Re: Chevron Service Station No. 9-3600
2200 Telegraph Avenue
Oakland, CA

Re: Work Plan for Soil Borings
Chevron Service Station 9-3600
2200 Telegraph Avenue
Oakland, California
Fuel Leak Case RO0002435

ACEH SEPTEMBER 11, 2008 LETTER

figure 2

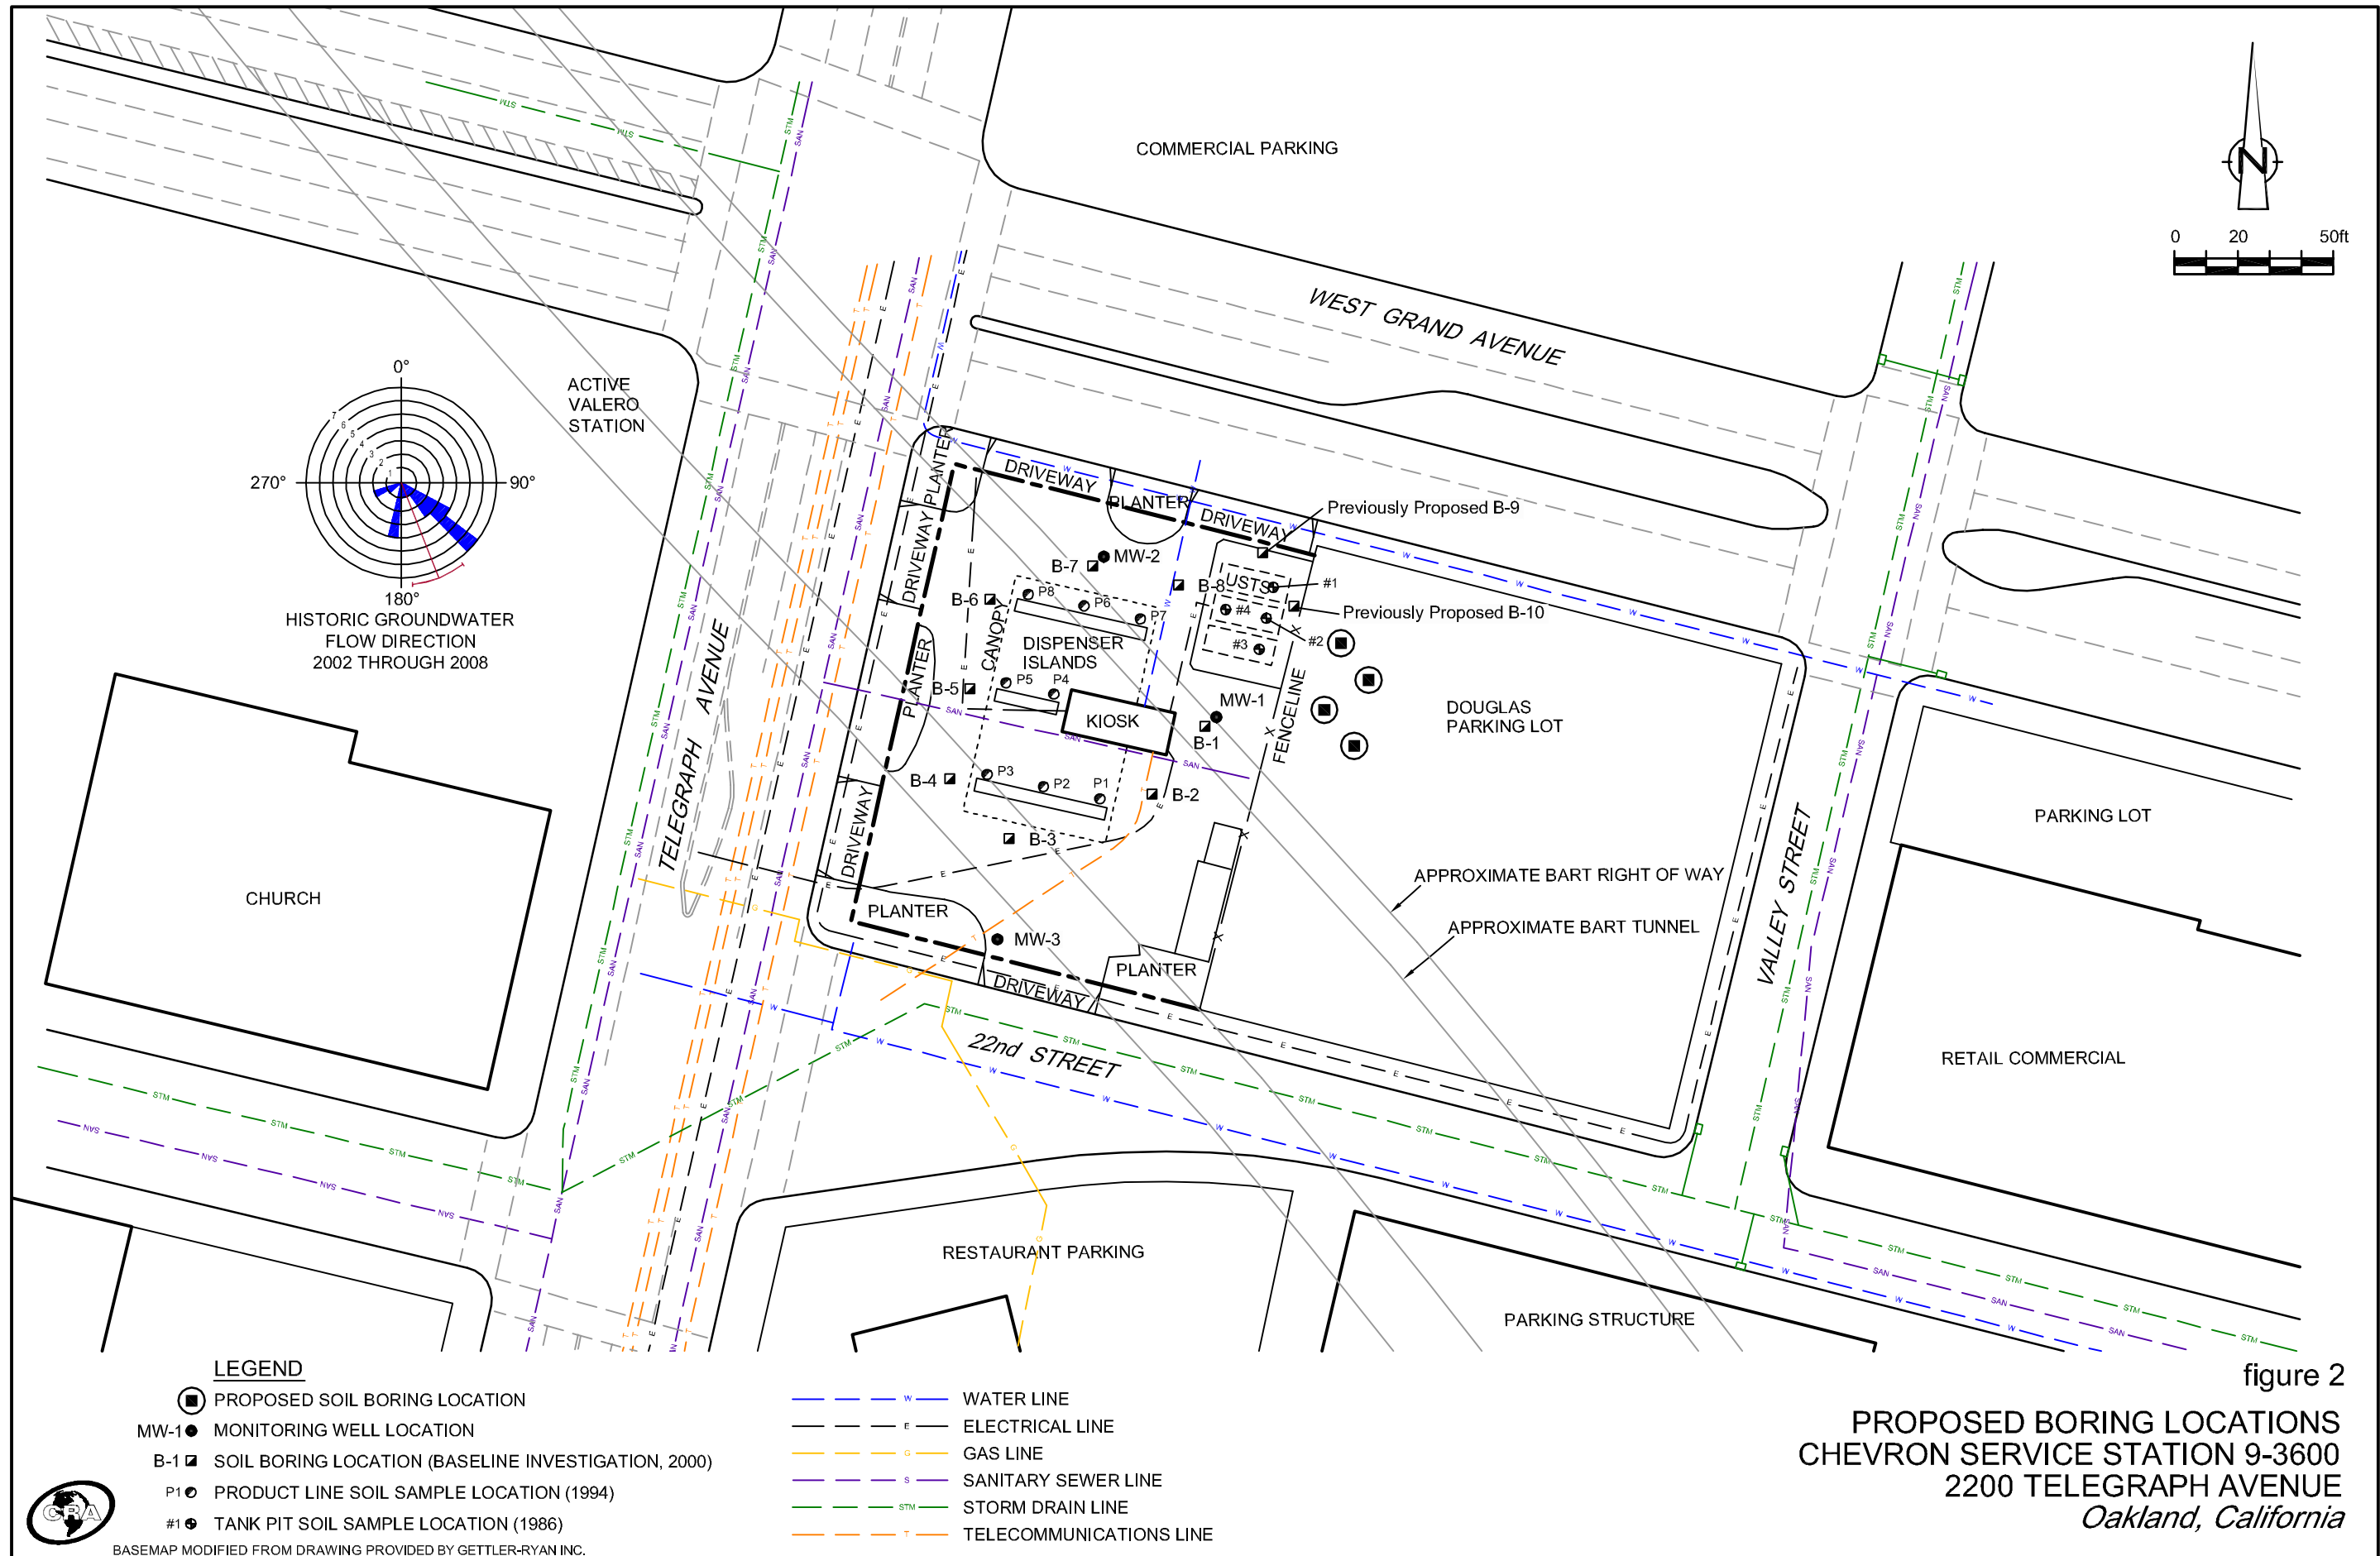
ACEH has requested that the originally proposed borings, B-9 and B-10, adjacent to the UST pit, be installed. It was not stated in the original report why the borings could not be advanced.

- Boring B-9: Based on current site configurations, the UST pit is actually within 2 feet of the sidewalk along West Grand Avenue. A water line runs within the sidewalk, approximately eight feet away from the UST pit. Due to safety concerns, this boring cannot be advanced and the site plan will be updated to show the correct dimensions and utility locations (Figure 3).
- Boring B-10: The UST pit is also bordered by a fence that defines the property line. There is no room on the property to install boring B-10. There is also a billboard in the northwestern corner of the offsite property, near the UST pit and adjacent to the property line, which further restricts access.

- One soil boring be advanced offsite, downgradient from the originally proposed boring B-10 and approximately 15 feet southeast from the property line, and one more boring be advanced in transect towards the BART right-of-way; and
- Two soil borings be advanced approximately 20 feet further southeast (downgradient) for plume delineation. Proposed boring locations are presented on Figure 2.
